#### Re: Georgia Power Company – Plant Branch Proposed CCR Landfill – Site Acceptability Review Comments APL 1579

Enclosed please find Georgia Power Company's (GPC) response to comments on the Site Acceptability Report (SAR) submitted for the proposed Plant Branch CCR Landfill. The comments were received in a letter dated October 23, 2019, which were generated by EPD's review of the Site Acceptability Report prepared by Geosyntec. Following are each of the comments from the EPD and a written response.

Response to SAR Comments – Proposed CCR Landfill Georgia Power – Plant Branch – Putnam County, Georgia Georgia Environmental Protection Division January 2020

PHONE: 678.202.9500 WWW.GEOSYNTEC.COM 1255 ROBERTS BOULEVARD NW, SUITE 200 KENNESAW, GEORGIA 30144-3694 GW6364 DWG. 6364-F3-1 EDIT 11.15.19 1" = 250' FIGURE 3 -1 NOVEMBER 2019

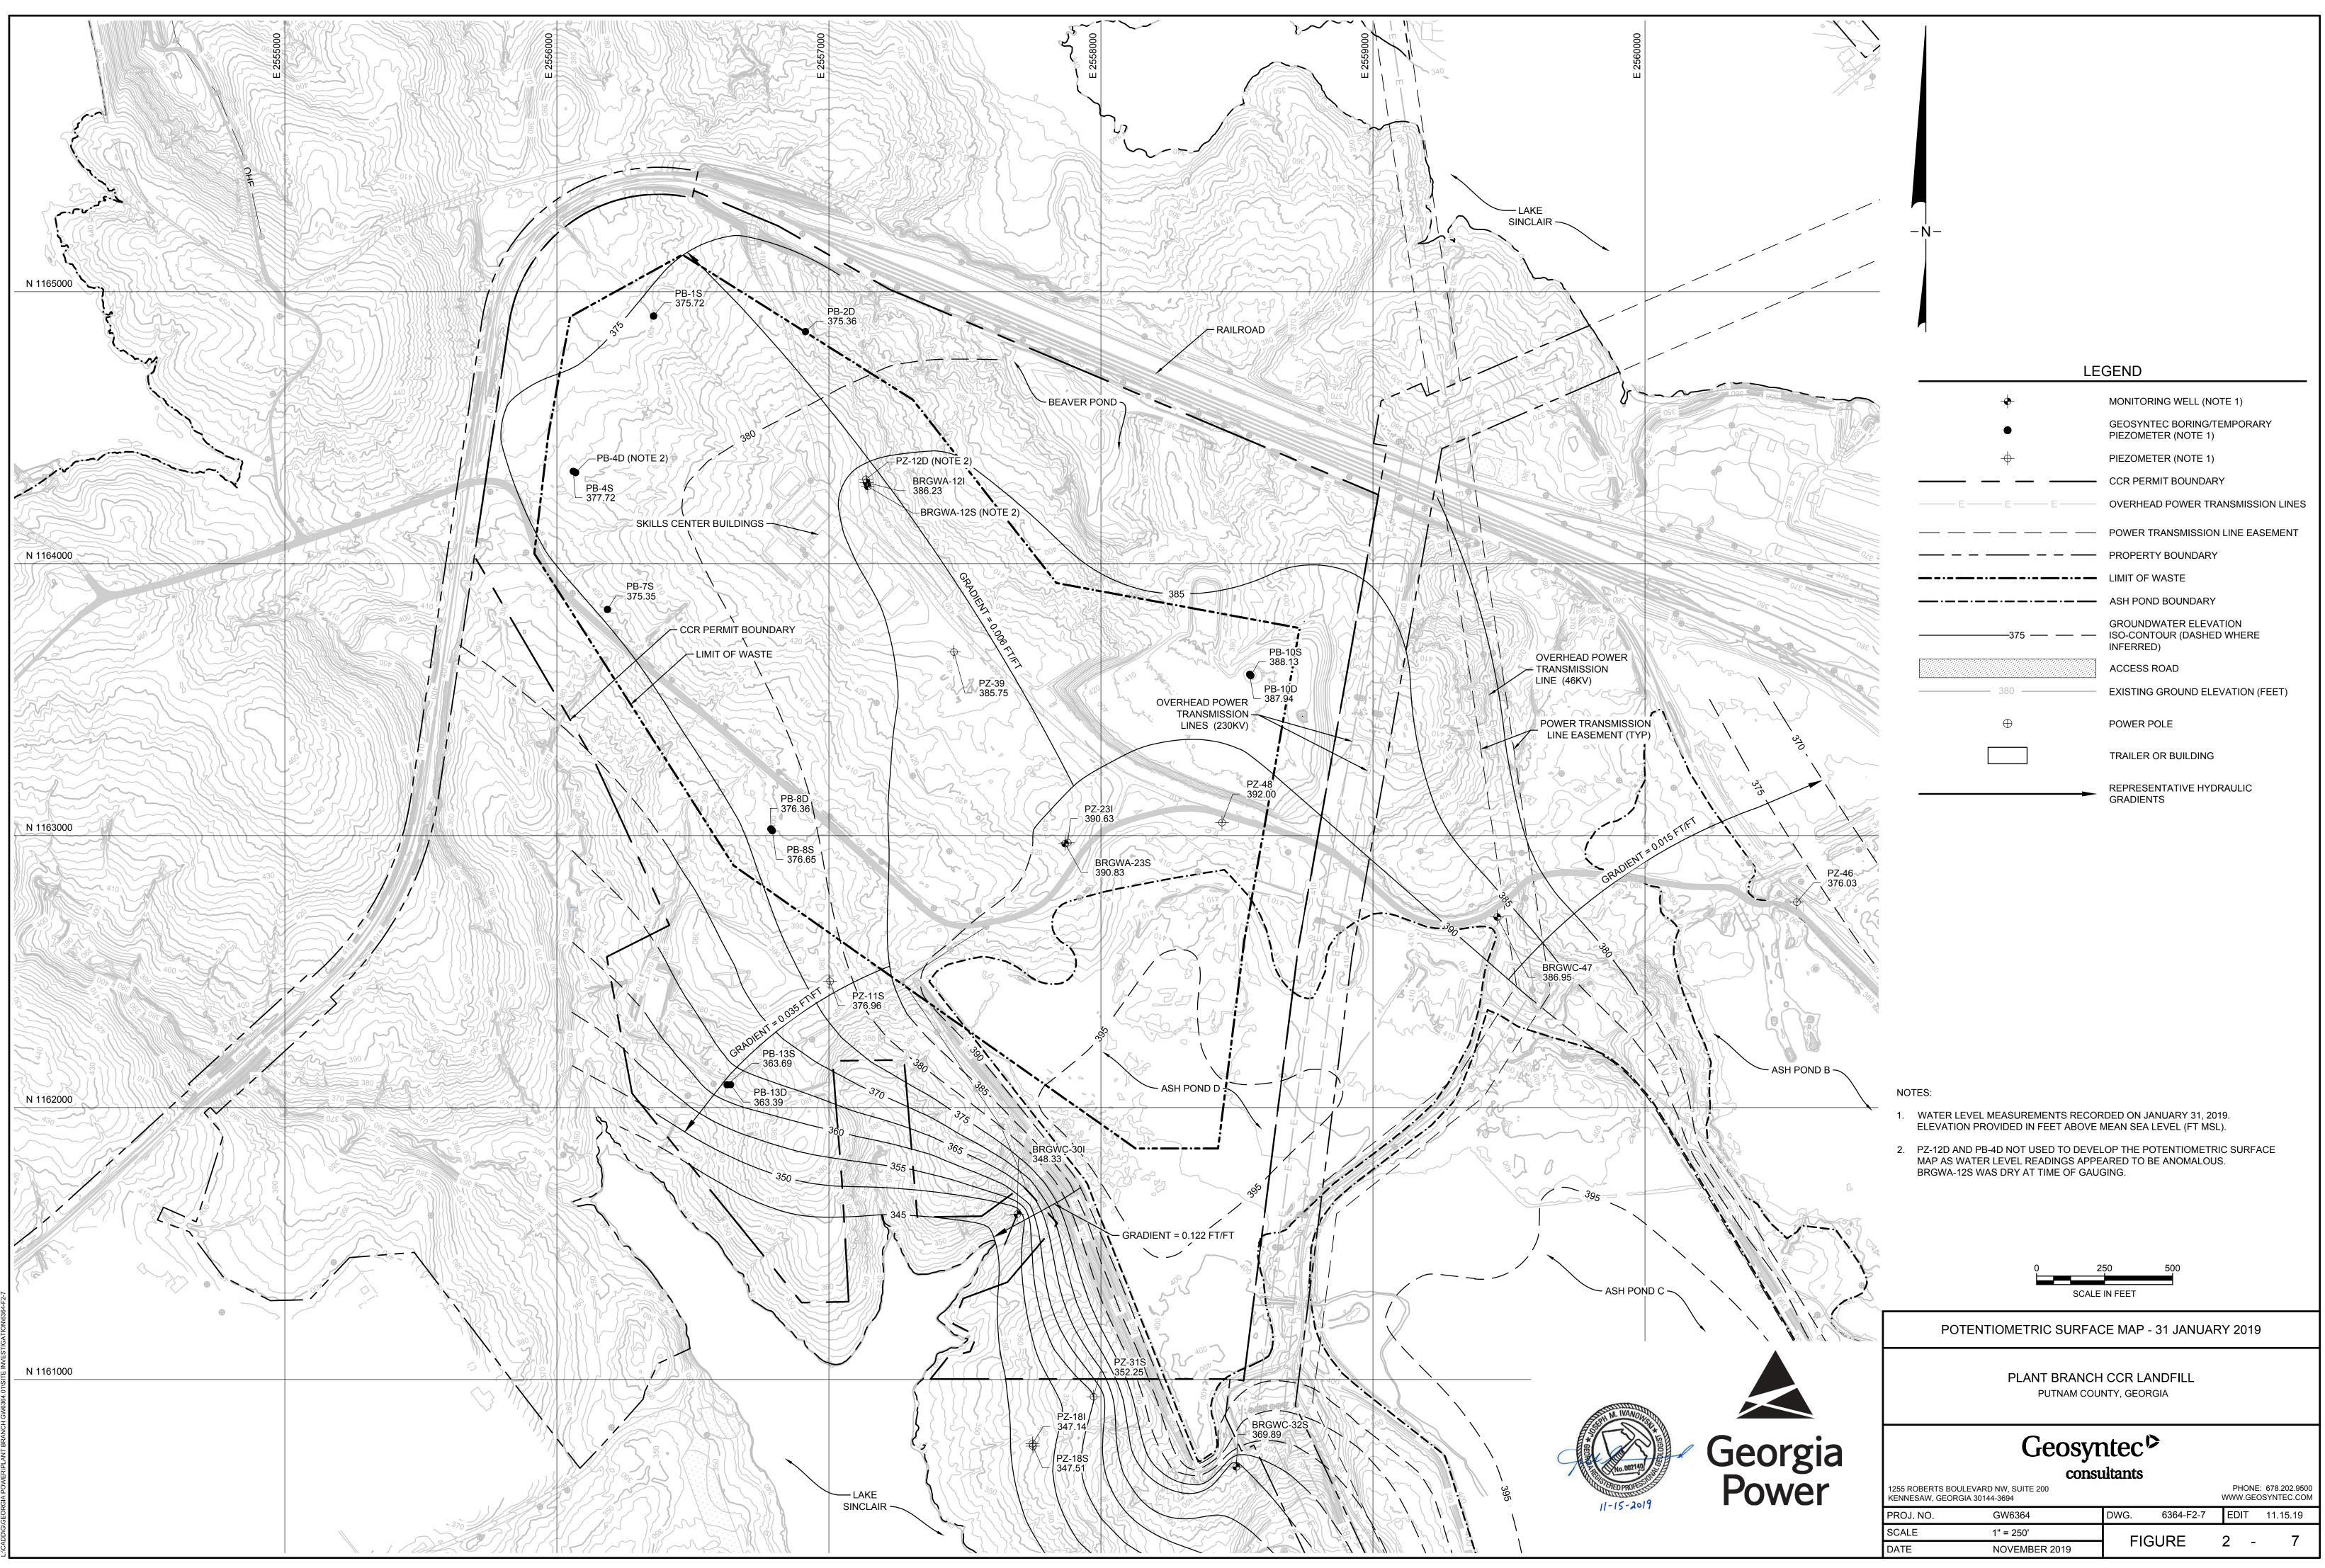
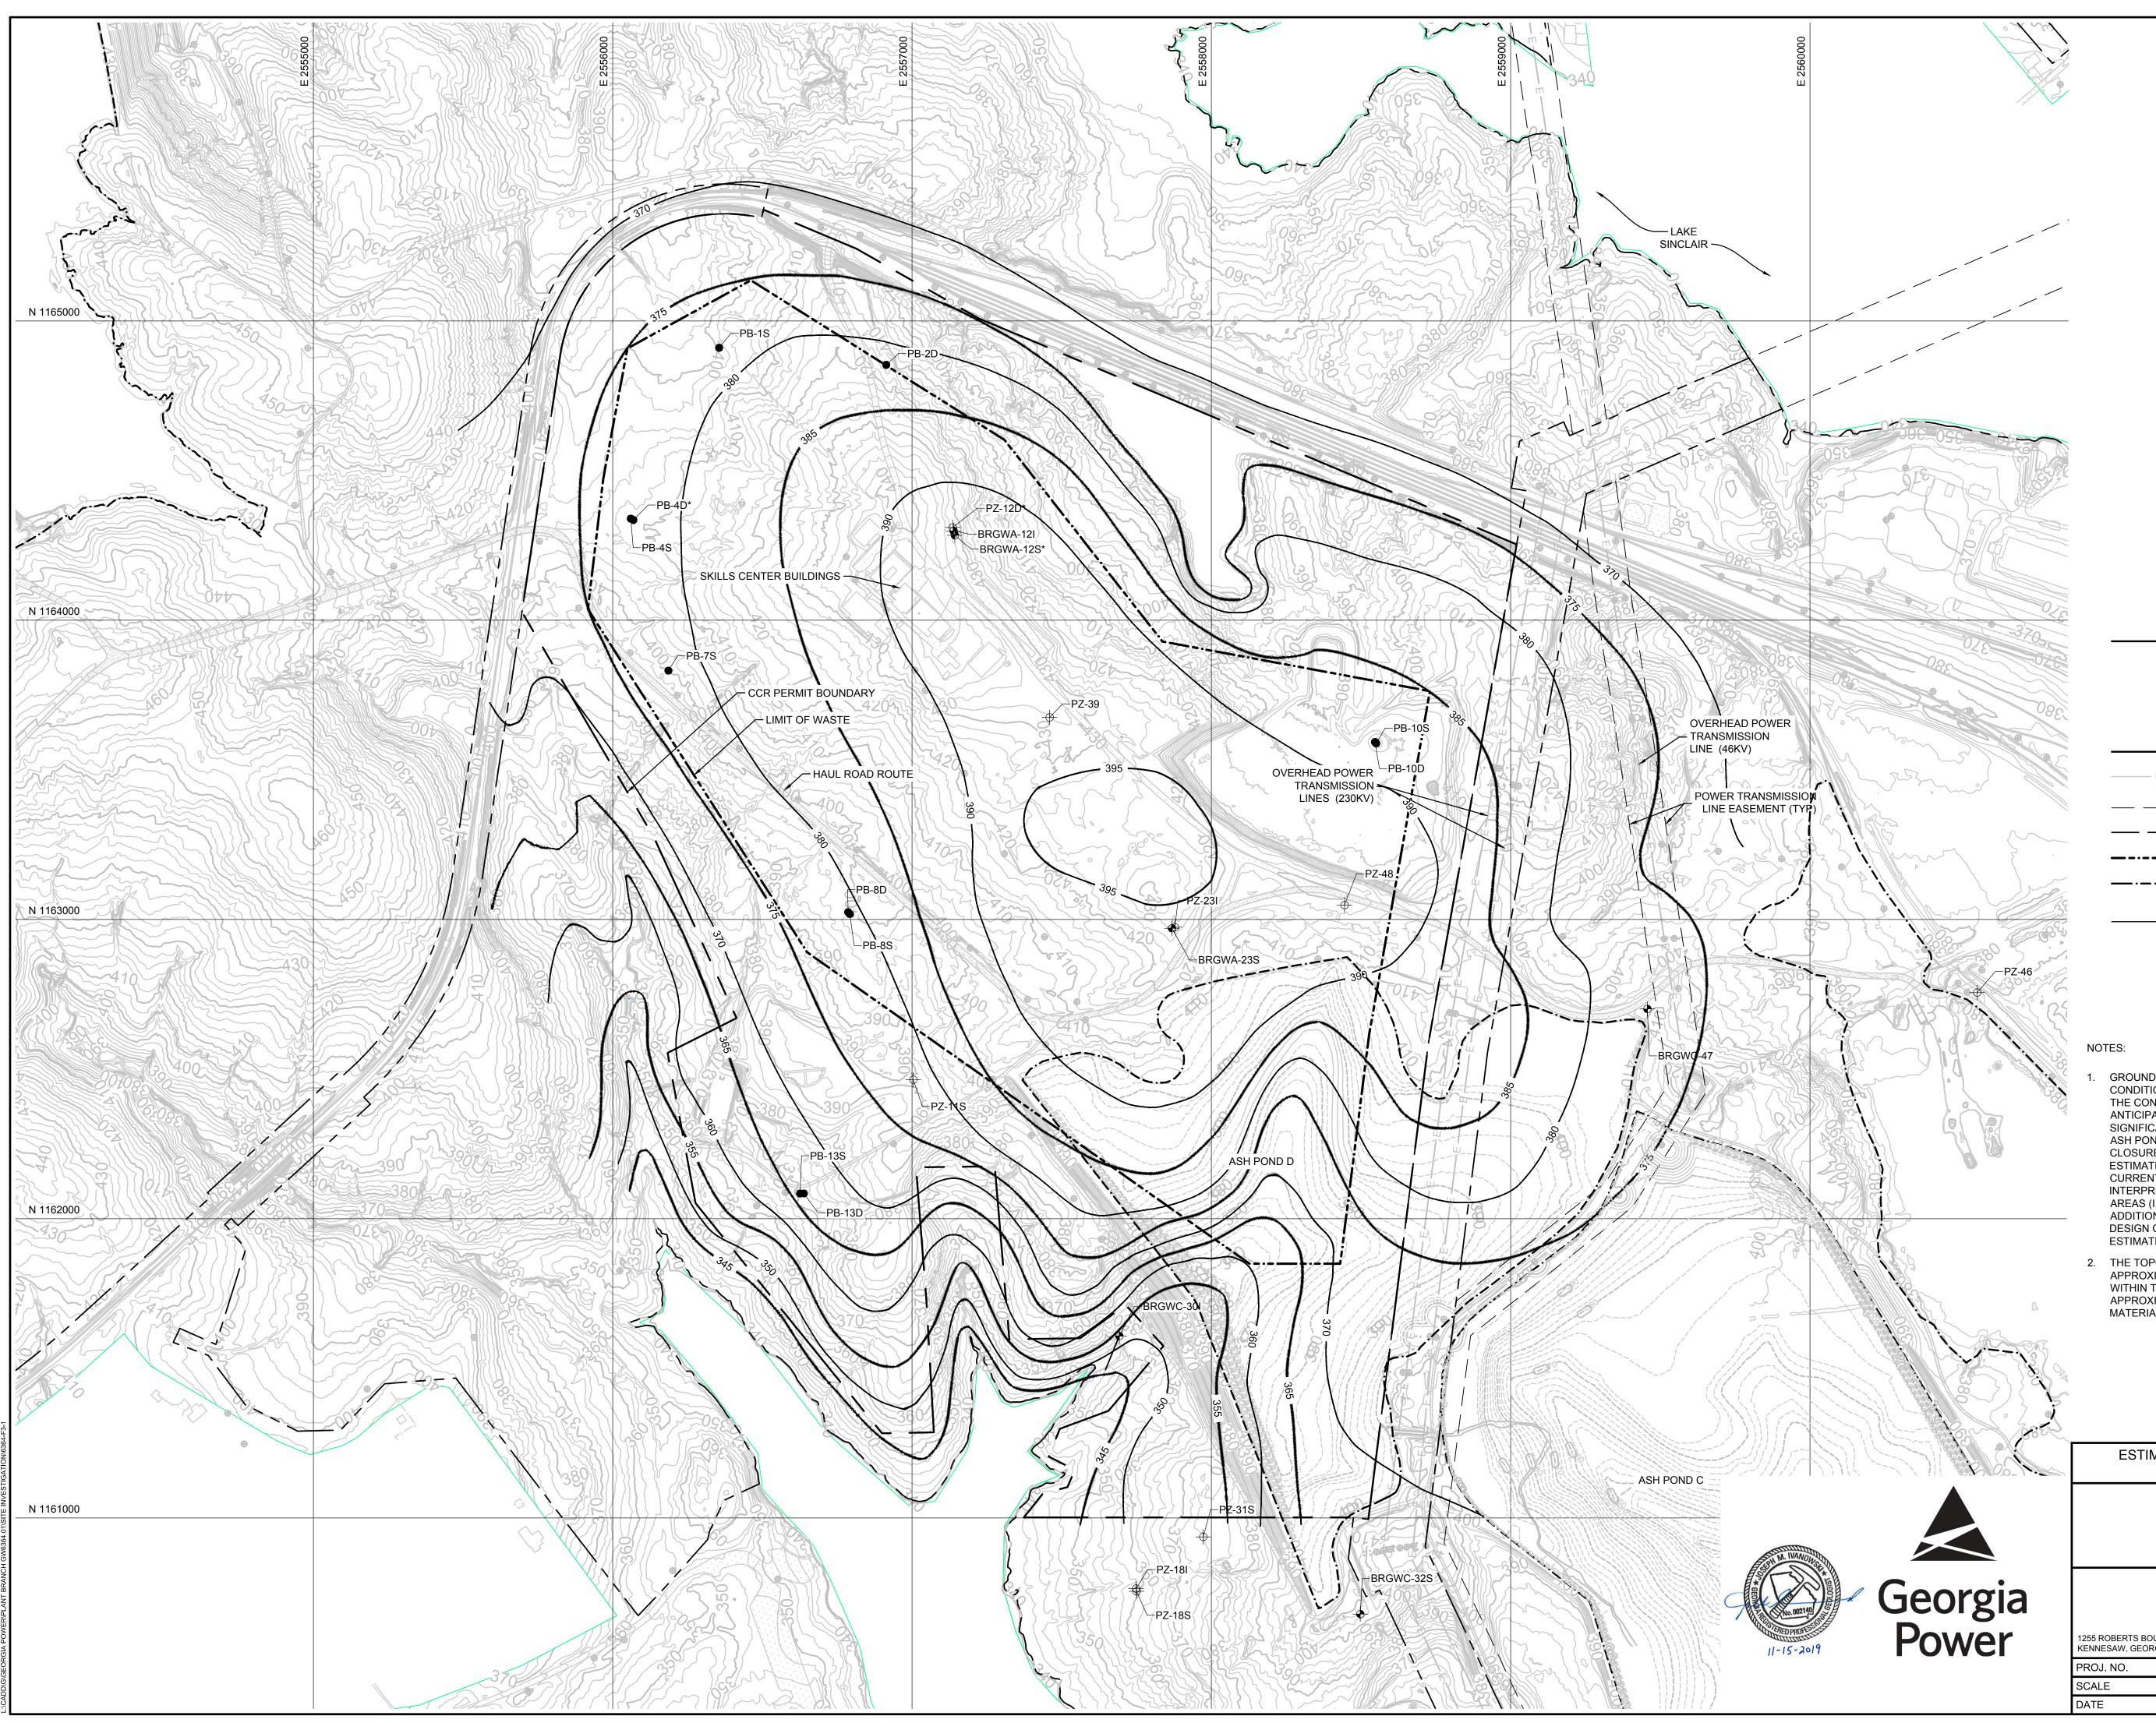
**<u>Comment No. 8:</u>** The groundwater elevation values used to generate the estimated seasonal high potentiometric surface (Figure 3-1) should be tabulated and posted on the figure.

**Comment No. 9:** The original topography beneath Ash Pond D should be overlain on Figure on 3-1 to help evaluate the estimated seasonal high potentiometric surface after removal of Ash Pond D. The report should indicate what specific data was used to forecast the future groundwater elevations in the area of Ash Pond D following breaching of the pond dike and dewatering and removal of the ash.

**Response:** The potentiometric surface presented in Figure 3-1 is an estimated or projected surface based on multiple lines of evidence, including historical water level data, seasonal groundwater fluctuations, "pre-ash" topography and surface water drainage at Ash Pond D, and projected conditions following closure of Ash Pond D, as described in more detail under the response to Comment No. 9. Groundwater elevation values could be estimated at each individual

well based on the projected surface, but these would be estimates only, interpolated between the 5-foot contours of the projected post-closure groundwater surface, and therefore, we do not recommend including these values in tabular format.

**Response:** The original "pre-ash" topography beneath Ash Pond D has been added to Figure 3-1, and the revised figure included in Attachment B. The estimated seasonal high potentiometric surface after removal of CCR presented in this figure is based on several factors, namely (i) observed groundwater elevations, (ii) seasonal variations from historical measurements, (iii) "pre-ash" topography and surface water drainage at Ash Pond D, and (iv) conditions likely to result from the construction of the proposed CCR landfill.
